AMEREN/UE  
DOCUMENT CONTROL SYSTEM  
DOCUMENT TRANSMITTAL

TEMPORARY CHANGE NOTICE REQUEST FORM

TCN NO. 00-400

1. PROCEDURE NUMBER EIP-ZZ-C0010 REVISION NO. 021
PROCEDURE TITLE EMERGENCY OPERATIONS FACILITY OPERATIONS

**BEOF LAYOUT**

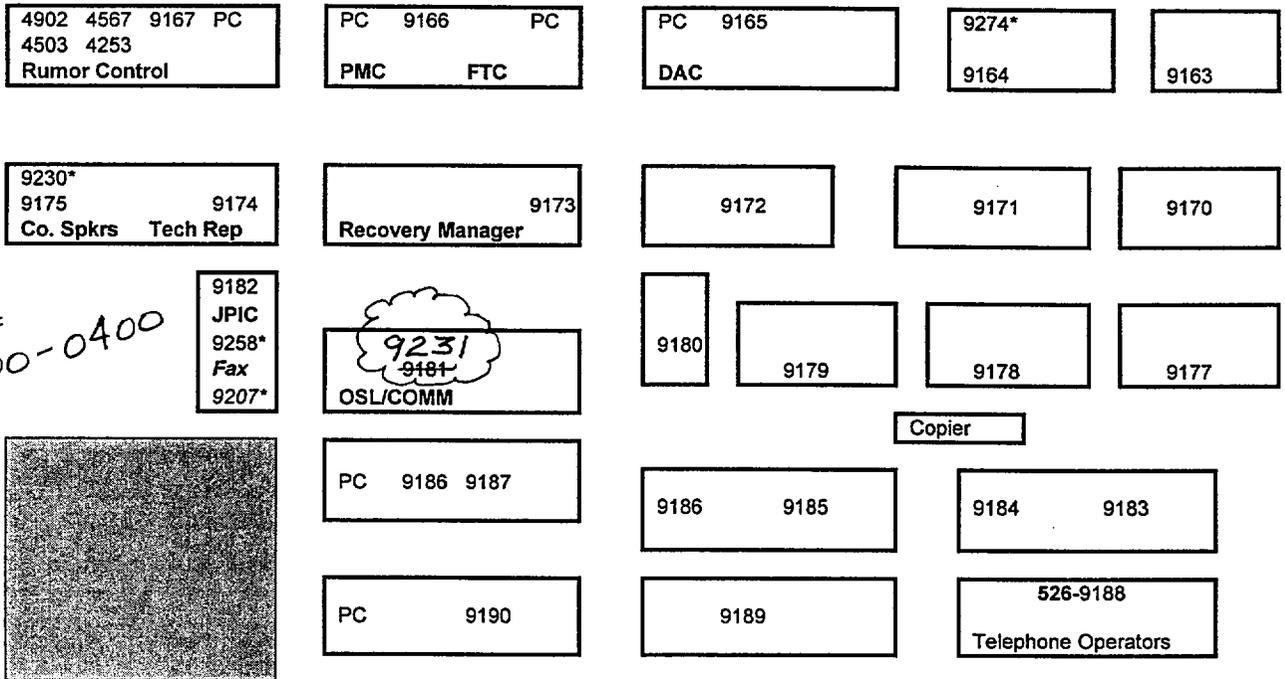
This change is to correct the Off Site Liaison Coordinator's phone number in the Backup EOF (SEMA Emergency Operations Center).
